**Re: GE-Pittsfield/Housatonic River Site
Rest of River (GECD850)
Response to EPA's Specific Comment 52 on Corrective Measures Study Report**

Discussion of Model Input Differences: EPA's Specific Comment #52 on GE's CMS Report

"Deep Hole" Grid Cells Simulated in Model

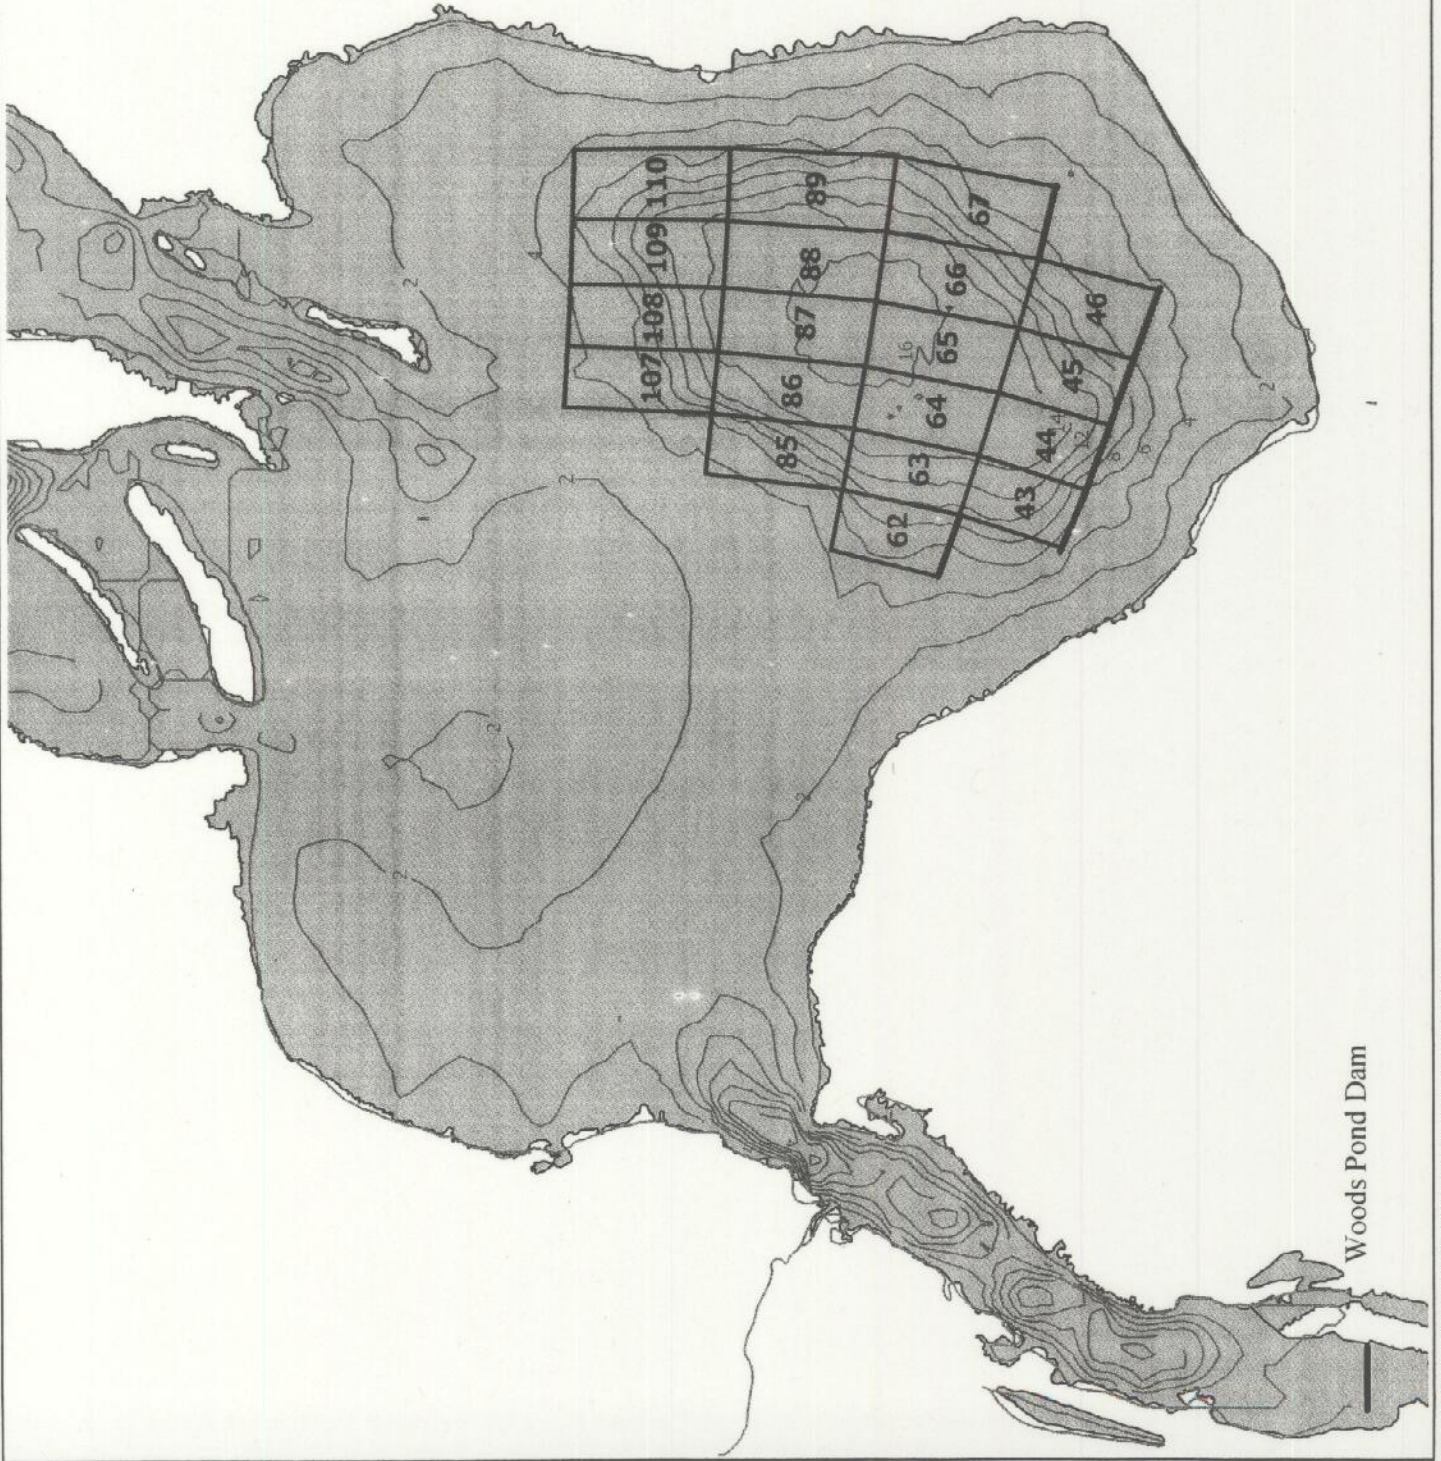
- 3) *The spatial extent of the "deep hole" in Woods Pond used by GE is larger than used by EPA.*

As shown in the attached figure of Woods Pond, GE's selection of grid cells used to represent the "deep hole" was based on the EPA bathymetry contours. This figure demonstrates that the GE-selected grid cells reasonably represent the deep portion of the Pond. It is currently unclear how EPA opted to define the deep hole in the model, and how this definition differs from GE's. Nonetheless, GE expects that differences in the

delineation of the deep hole would likely not have a material effect on model predictions, since all scenarios that include any remedial action (SEDs 3 through 8) specify remediation over the entire Pond. Although several of the CMS alternatives use different remedial technologies in shallow versus deep areas of the Pond, the Pond-wide average surface sediment concentration (immediately following completion of remediation) is not significantly affected by these differences. For example:

Both of these examples illustrate that small differences in the specific model grid cells used to define the deep hole area within Woods Pond would likely not materially impact the model results that were used in comparing the sediment alternatives. To confirm this, EPA would need to provide GE with a list of specific model grid cells it used to define the deep hole in Woods Pond, and the model would need to be re-run for alternatives SED 3 through SED 7.
